HISTORIC LANDMARK COMMISSION
PERMITS IN NATIONAL REGISTER HISTORIC DISTRICTS
OCTOBER 22, 2012
NRD-2012-0093
416 E. 6th Street
Sixth Street

Install a new metal guardrail at the parapet to extend the roof deck.

Picture 1 - HVAC on roof
Existing

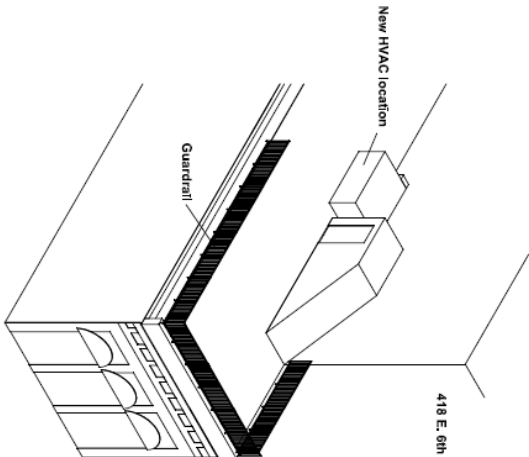
The applicant is incurring a large cost for relocating the air conditioning unit, which is a significant eyesore on the front of this building to comply with architectural design guidelines regarding mechanical equipment and improve the appearance of the building from the street.

Guardrail and relocated HVAC
Proposed

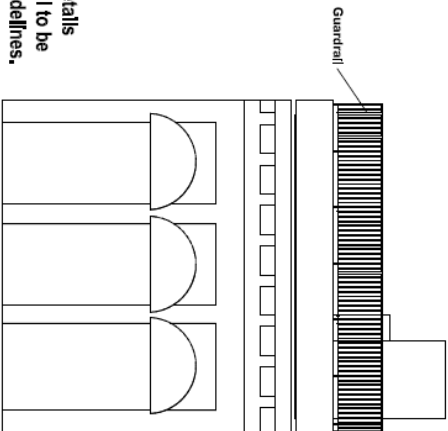
Staff recommends approval of the application, even though the project violates several tenets of the Sixth Street Architectural Design Guidelines. Removal of the rooftop air conditioning unit will go a long way to improve both the historic and general appearance of this building, and the proposed simple metal guardrail at the parapet wall is not an uncommon intrusion on Sixth Street. Future projects will comply with the design standards that arise out of the Downtown Austin Plan, which recommends that all rooftop additions, including roof decks, be set back a minimum of 15 feet from the front wall of the building in the historic district.
